Recalled Product

WGX1031B- 9"x 9"-Standard Flow replacement cover and inner frame Flow rate listed at 112 GPM (floor) – 83 GPM (wall)

WGX1033B- 18"x 18"-Standard Flow replacement cover and inner frame Flow rate listed at 560 GPM (floor) – 560 GPM (wall)

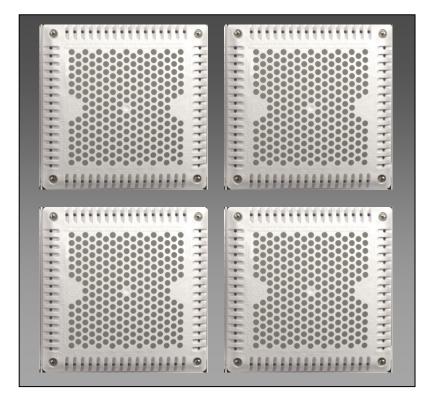
Recalled Product

WGX1033BHF- 18"x 18" High Flow replacement cover and inner frame Flow rate certified at 812 GPM (floor) – 732 GPM (wall)

WGX1033BLV- 18"x 18" Low Velocity replacement cover and inner frame Flow rate certified at 520 GPM (floor) – 520 GPM (wall)

WG1032PAK2- 12"x 12"-Standard Flow 2 pack cover, inner frame & outer frame Flow rate listed at 256 GPM (floor) – 112 GPM (wall)

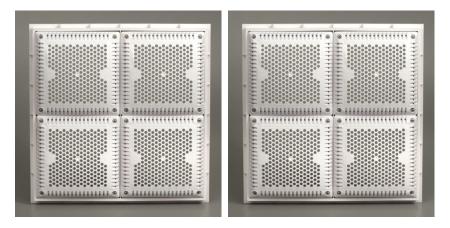
Recalled Product

WG1032HFPAK2- 12"x 12" High Flow 2 pack cover, inner frame & outer frame Flow rate certified at 515 GPM (floor) – 308 GPM (wall)

WG1032LVPAK2- 12"x 12" Low Velocity 2 pack cover, inner frame & outer frame Flow rate certified at 392 GPM (floor) – 260 GPM (wall)

WGX1031BHF- 9"x 9" High Flow replacement cover and inner frame Flow rate listed at 440 GPM (floor) – 224 GPM (wall)

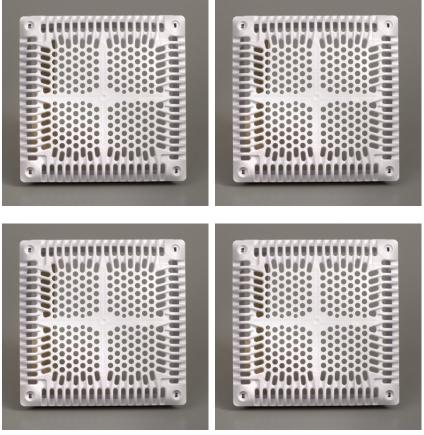
Recalled Product

*WGX1031BHF- 9"x 9" High Flow replacement cover and inner frame Flow rate certified at 264 GPM (floor) –224 GPM (wall)

*WGX1031BLV- 9"x 9" Low Velocity replacement cover and inner frame Flow rate certified at 190 GPM (floor) – 108 GPM (wall)

*<u>If either one of these products does not meet the verified maximum flow rate of your pool system</u> <u>contact Hayward to return the product and to receive a refund at (888)407-9281</u>
